ADDENDUM NO. 2

TO: PLANS AND SPECIFICATIONS FOR STATE OF MISSOURI

Replace Cooling Towers St. Louis Forensic Treatment Center - North St. Louis, Missouri PROJECT NO.: M2015-01

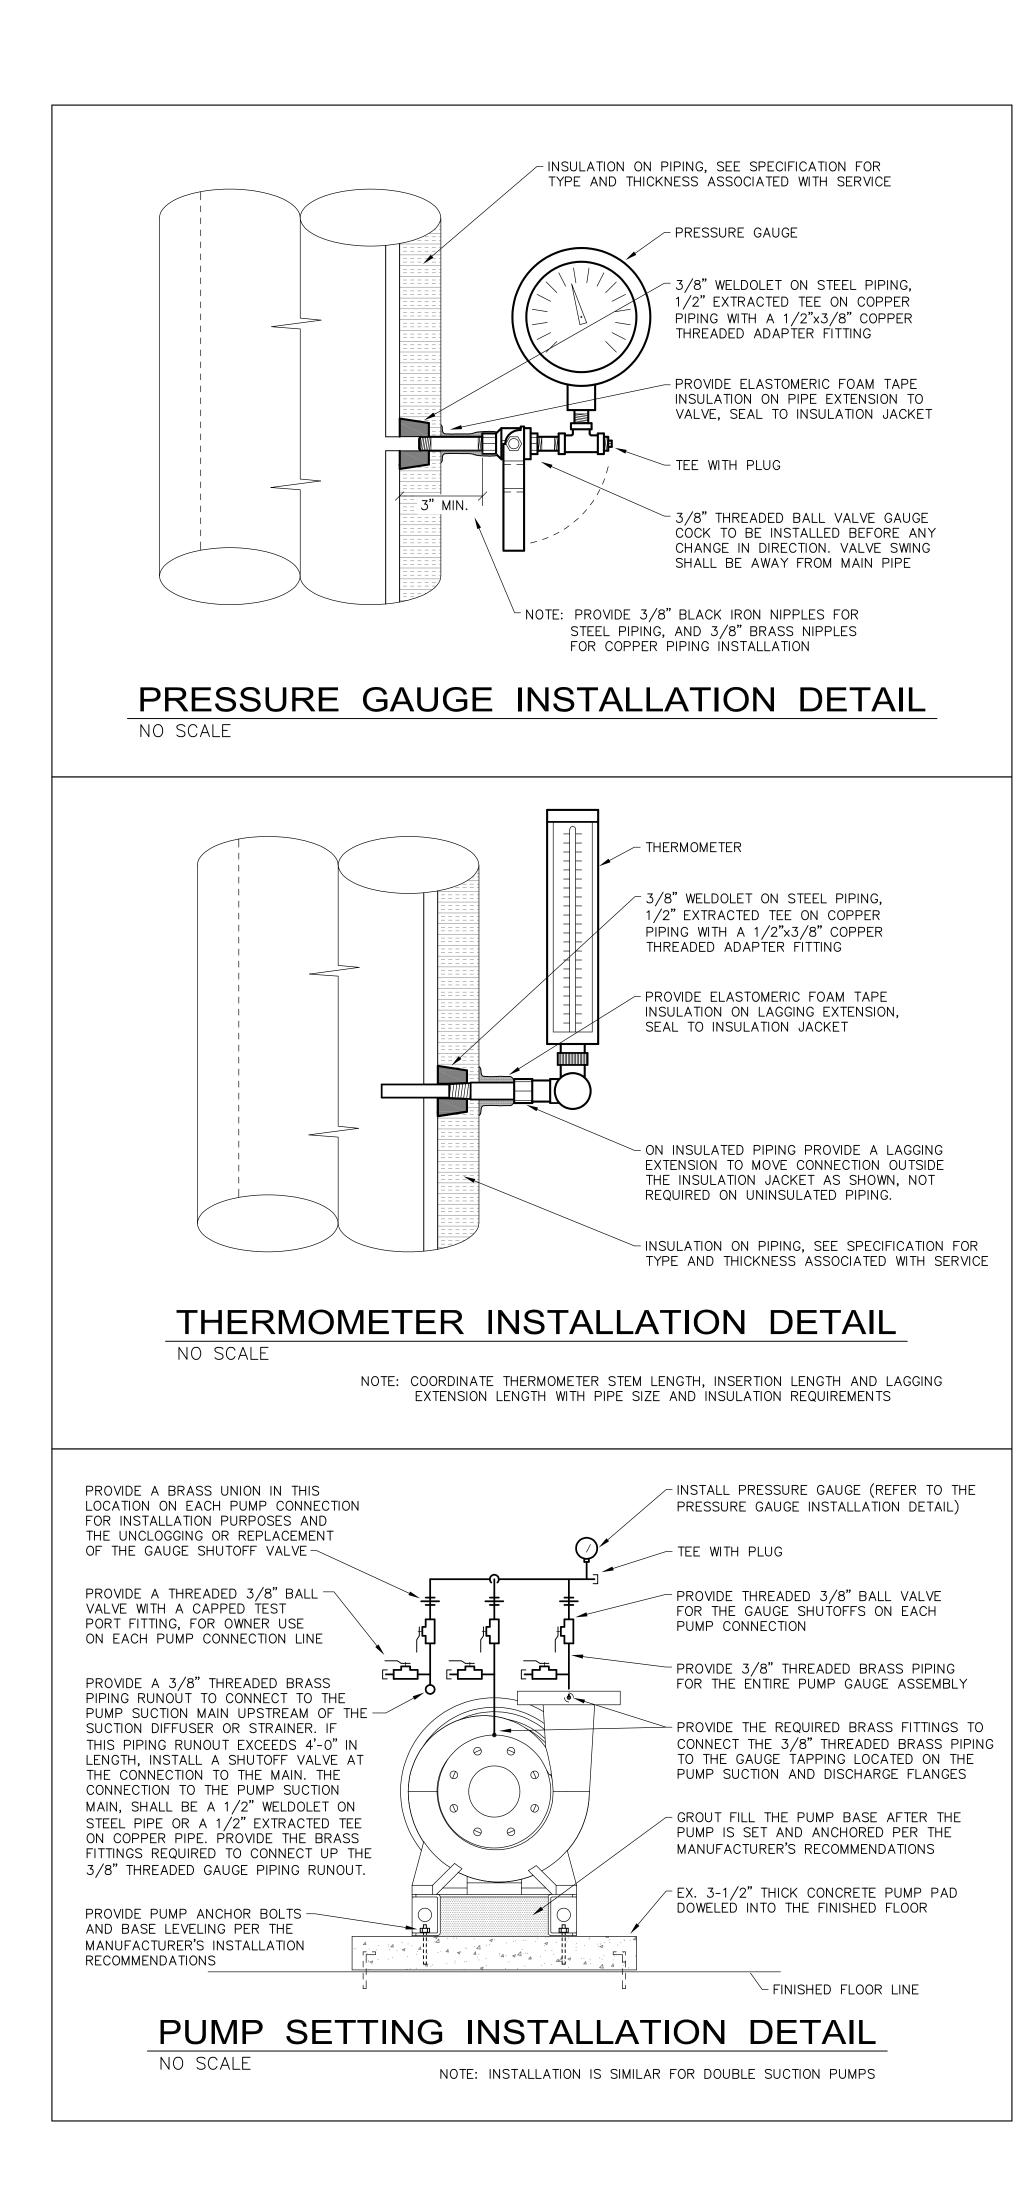
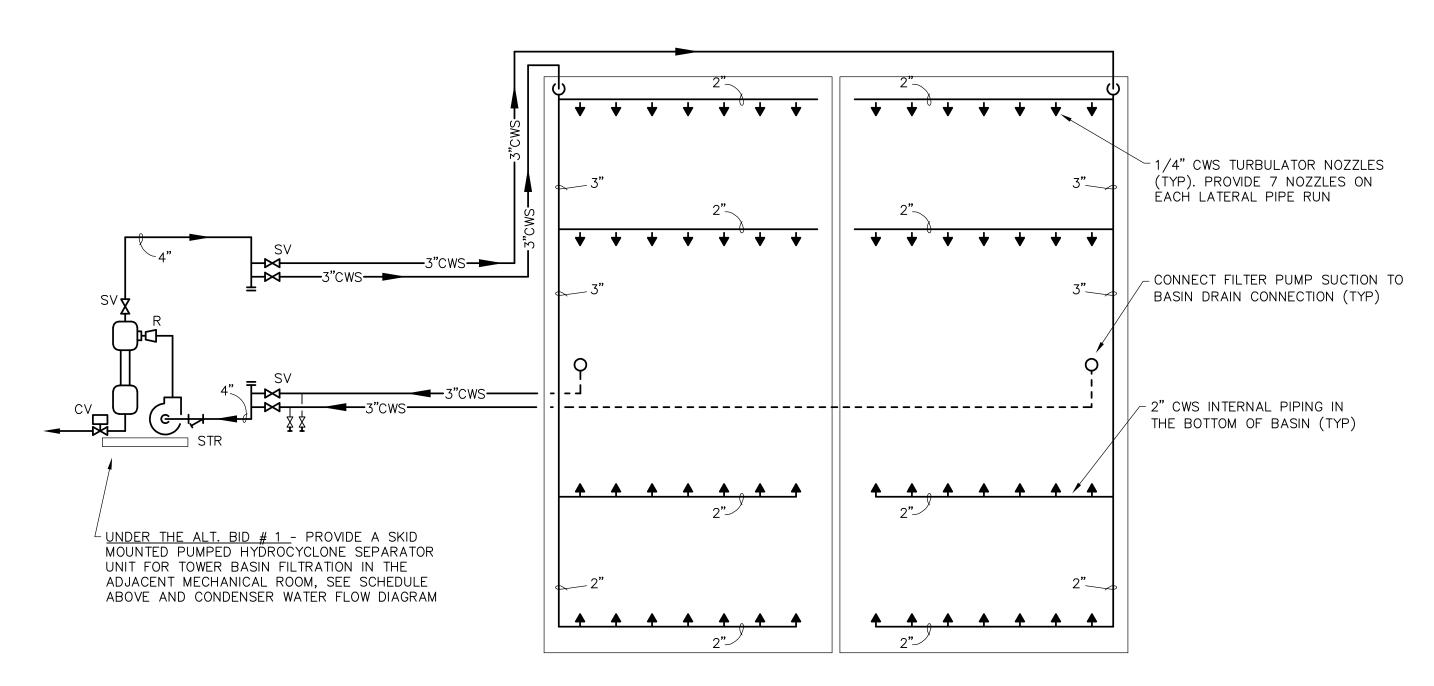
- 1. Drawing M-203
 - a. REVISE Cooling Tower Schedule Notes to read as follows:

Note 1: Under Base Bid: Provide towers with stainless steel hot and cold basins, galvanized steel structural components, galvanized casing panels, PVC fill with integral air inlet louvers and drift eliminators, and mechanical float valve for basin level (make-up water) control.

Note 2: Under Alternate Bid #3: All structural steel components shall be constructed from stainless steel.
